Appendix I of RNTPC
Paper No. A/YL-ST/578B

A/YL-ST/578

APPLICATION FOR PERMISSION
UNDER SECTION 16 OF
THE TOWN PLANNING ORDINANCE
(CAP.131)

Responses to Comments from Various Government Departments on Planning Application No. A/YL-ST/578

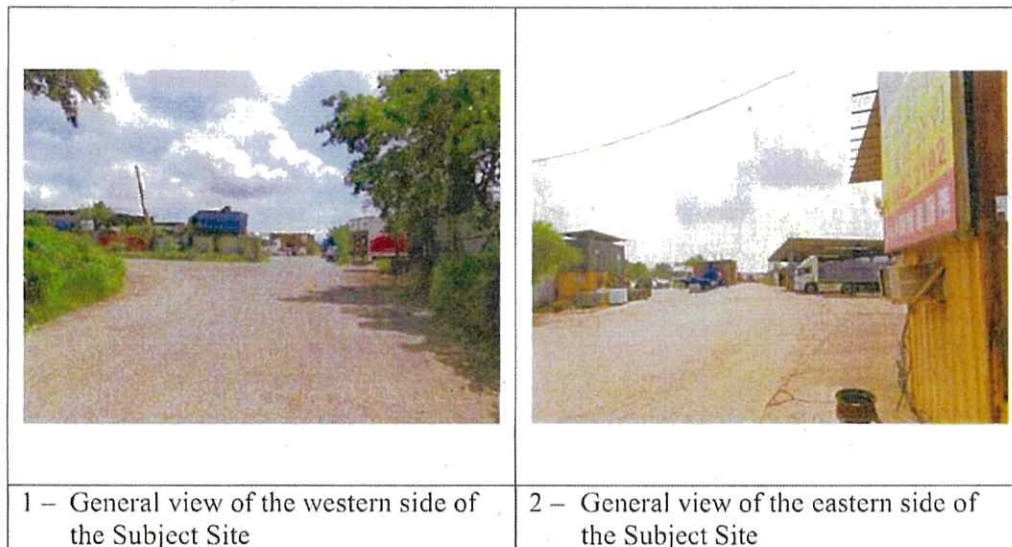
- (a) The applied planning permission period should be 18 months instead of 3 years as indicated in the Environmental Assessment Report;
- (b) The site area of the Application Site should be 70,679m² instead of 17,480m² as indicated in Section 3.1 of the Drainage Submission.

PROPOSED STORMWATER DRAINAGE PLAN

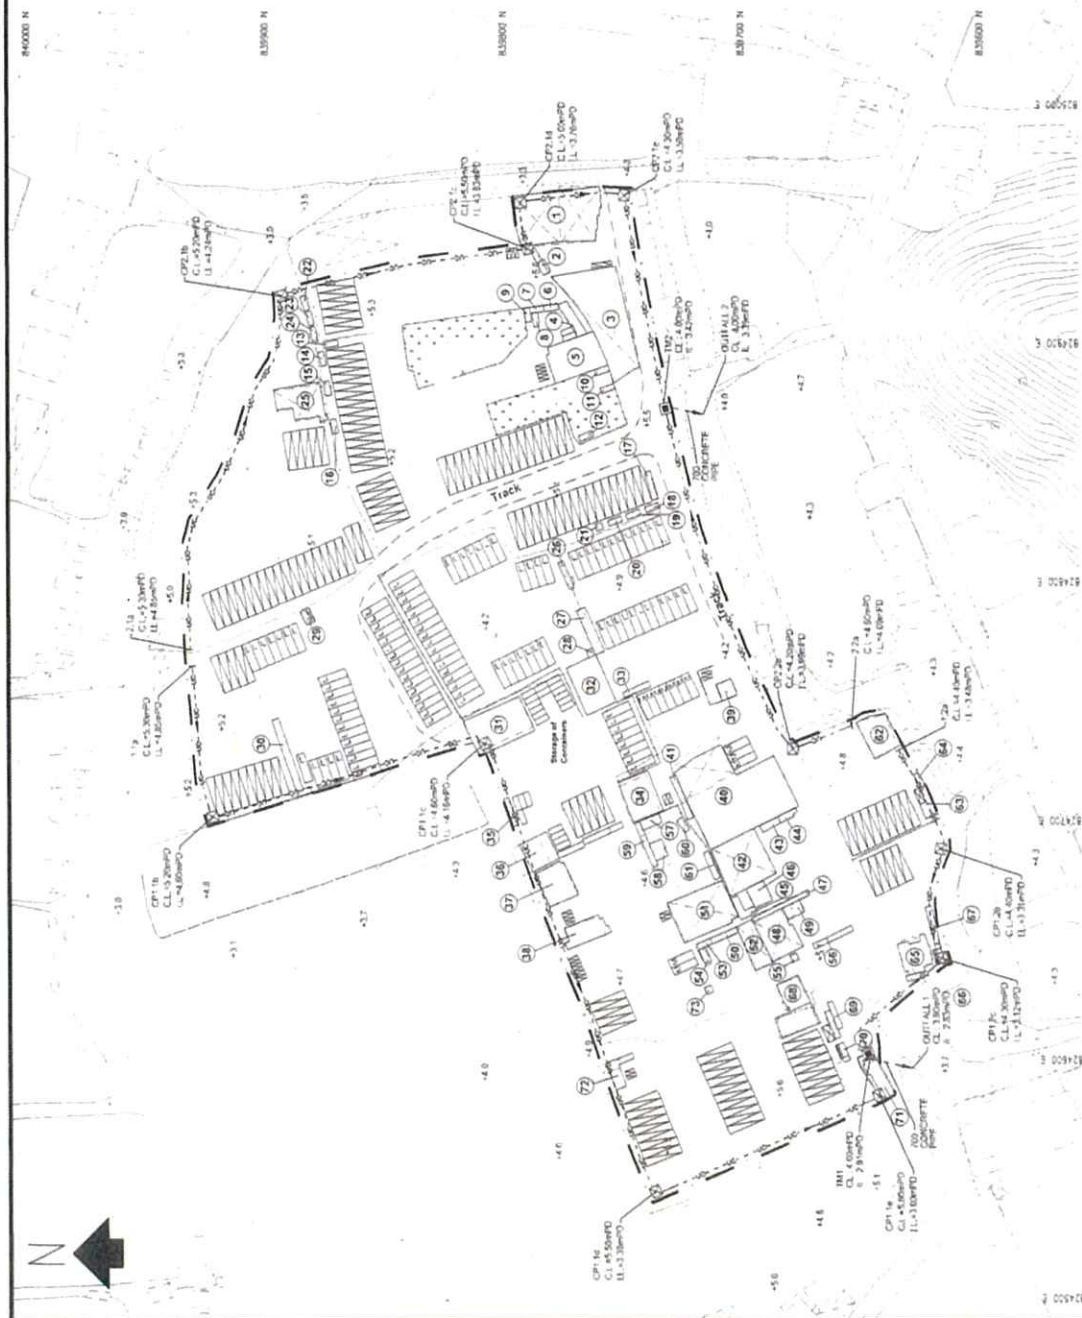
COMMENTS	RESPONSES
<p>A clear drainage plan showing full details of the existing drains & the proposed drains (e.g. cover & invert levels of pipes/catchpits/outfalls and ground levels justifying waterflow etc.) with supporting design calculations & charts should be included. (For preparation of the drainage proposal, the Guideline on preparation of the drainage proposal is available in DSD homepage at http://www.dsd.gov.hk/EN/Files/Technical_Manual/dsd_guideline/Drainage_Submission.pdf for reference). The applicant is reminded that approval of the drainage proposal must be sought prior to the implementation of drainage works on site.</p>	
<p>(ii) After completion of the required drainage works, the applicant shall provide DSD for reference a set of record photographs showing the completed drainage works with corresponding photograph locations marked clearly on the approved drainage plan. DSD will inspect the completed drainage works jointly with the applicant with reference to the set of photographs.</p>	<p>(ii) The comment is noted and will be followed. A set of record photographs showing the completed drainage works with corresponding photograph locations marked clearly on the approved drainage plan will be submitted upon completion of the proposed drainage works.</p>

- (c) The Drainage Submission (Drawing No. HT20088/A/DD/001) (**Drawing A-3** of the RNTPC Paper) does not include provision of petrol interceptors / oil interceptors, etc., which contradicts paragraph 1.2.1.5 of the FI. Also, there is no floor drainage included to collect and divert polluted water from such potential polluting activities as vehicle repair, petrol filling, etc. activities to treatment before discharge. The applicant should review and provide sufficient treatment facilities to prevent adverse water quality impact from contaminated runoff. Silt traps and petrol interceptors shall be regularly maintained to ensure effectiveness during operation.
